Characterization of Regional Hydrologic Synthesis and Modeling

MARKED-UP COPY OF COLEMAN'S REVIEW

NRC PHASE II REVIEW OF DOE STUDY PLAN FOR
REGIONAL HYDROLOGIC SYNTHESIS AND MODELING
(STUDY PLAN NUMBER 8.3.1.2.1.4, REV. 0)

August 12, 1992

Figure 1.2-6. Subregional potentiometric surface (Czarnecki, 1989).

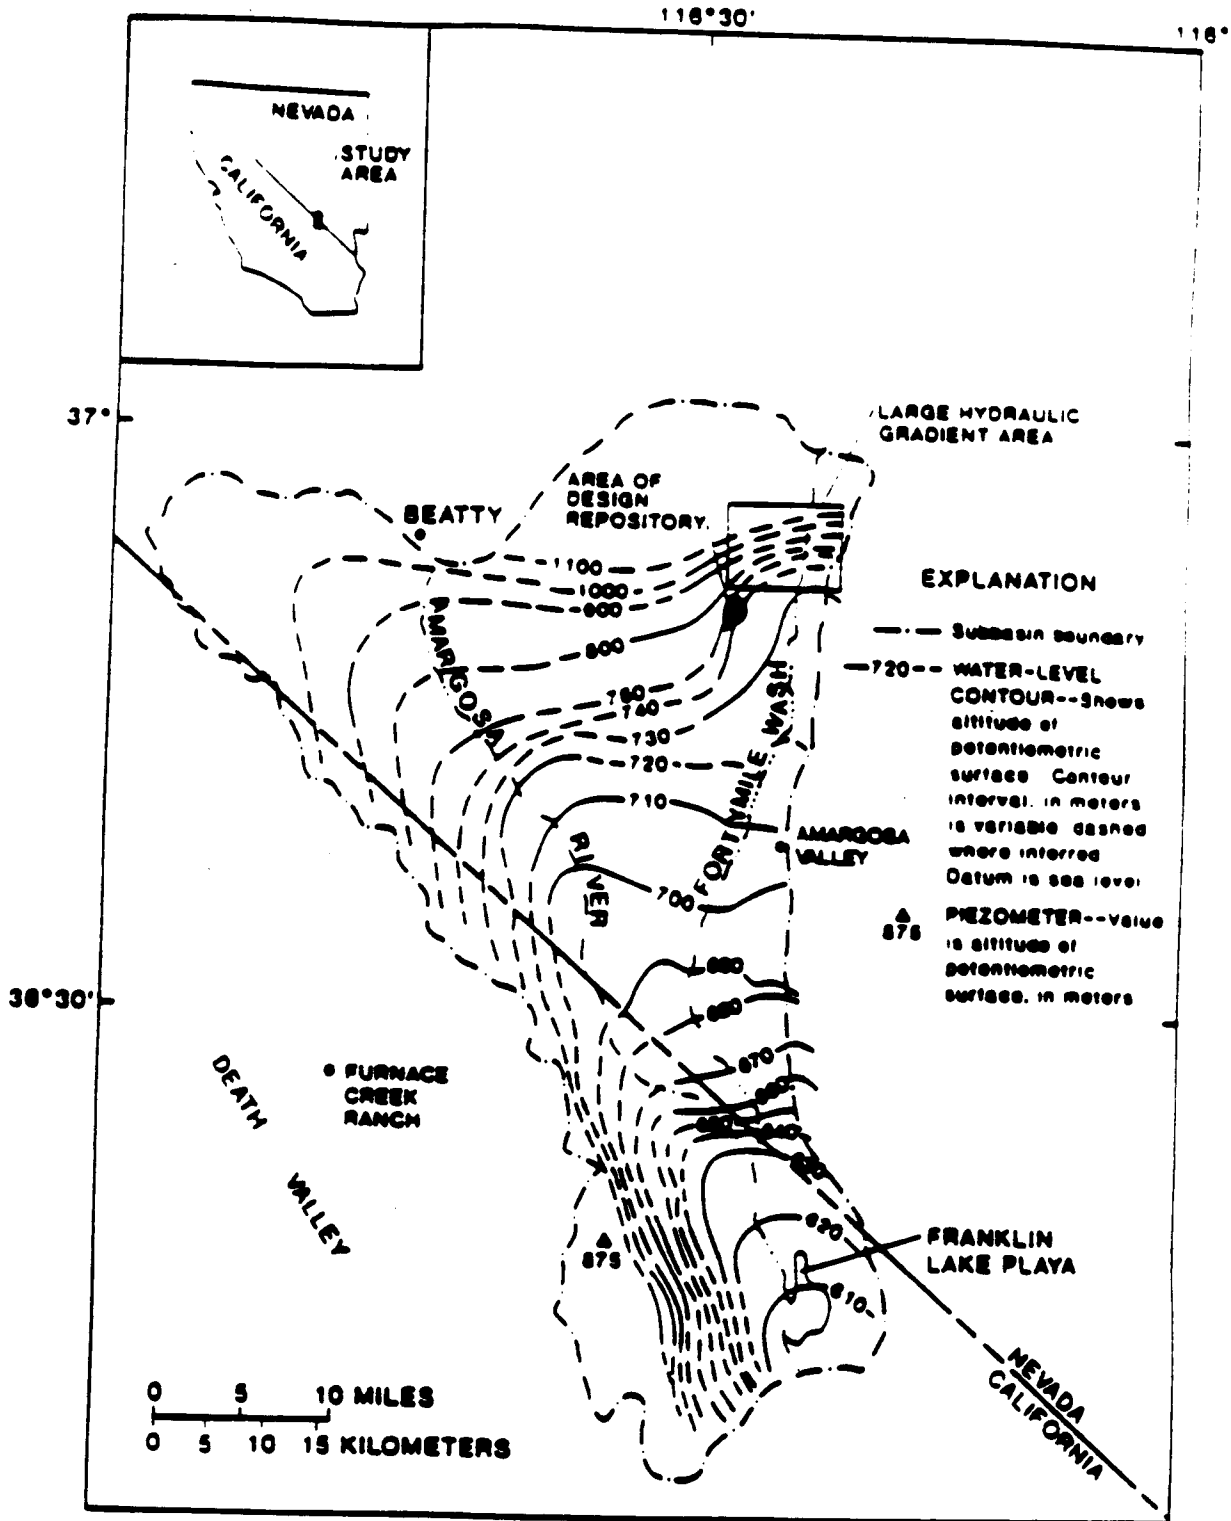
Czarnecki (1989) presented a new conceptual model of subregional groundwater flow. This new model is based on the acquisition of potentiometric data in the Greenwater Range showing the probable presence of a groundwater flow divide beneath this range. Overall, the potentiometric data suggest the possible need for model recalibration and revision of the model boundaries of Czarnecki and Waddell (1984) and Czarnecki (1985). Figure 1.2-6 (DOE, 1991) gives a new interpretation of the potentiometric surface based on the presence of a hypothesized flow divide beneath the Greenwater Range and the Funeral Mountains.

Given the importance of Czarnecki (1989) in presenting an alternate conceptual flow model, it is surprising that the subject study plan does not cite it. In fact, DOE (1991) does cite Czarnecki (1989) and includes a discussion about the alternate flow model. The next revision of the "synthesis" study plan should include an updated list of references related to regional modeling, including Czarnecki (1989). The study plan should also include a discussion of the process for determining when and if major revisions are needed for existing models. Finally, the DOE should aggressively continue the search for existing sources of potentiometric data in key areas such as the Funeral Mountains. Given the data collected in the Greenwater Range, the DOE should confirm whether these mountain ranges do

indeed contain groundwater divides. If existing sources of data cannot be located, it would be necessary to drill new boreholes to confirm whether major modifications to existing models are needed.

Figure 1.2-2. Location map of ground-water subbasin.

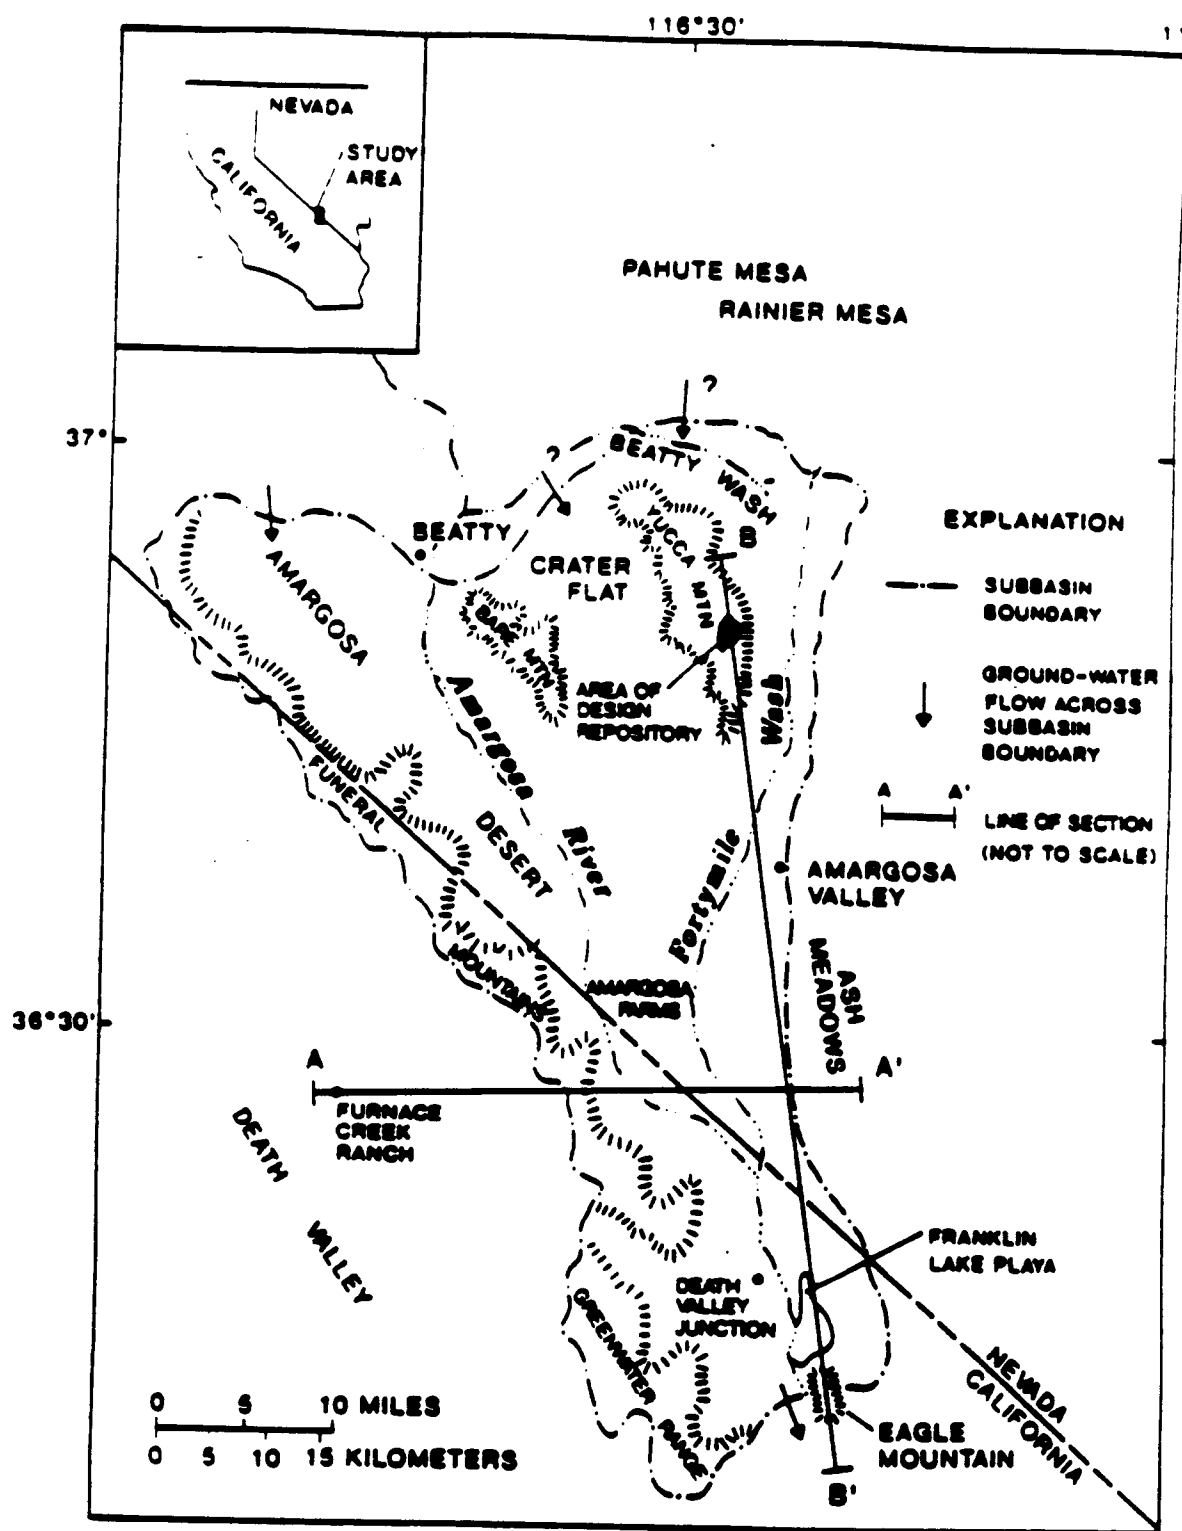
In Czarnecki's 1985 model, Franklin Lake Playa and Furnace Creek act as discharge areas for the water table aquifer. Based on the data from the Greenwater Range, Franklin Lake Playa may serve as the principal discharge area for the subregional water table aquifer that includes Yucca Mountain. Figure 1.2-2 shows the locations of cross-sections in the newly defined subregional flow system. Figure 1.2-4 shows a hypothesized east-west cross-section that extends from Ash Meadows to Furnace Creek Ranch in Death Valley. Under the new conceptual model, the Greenwater and Funeral mountain ranges serve as flow divides for the upper, water table system. Some groundwater is hypothesized to flow from the Amargosa Desert under the Funeral Mountains via the Paleozoic carbonate aquifer, finally contributing to spring discharge at Furnace Creek Ranch.
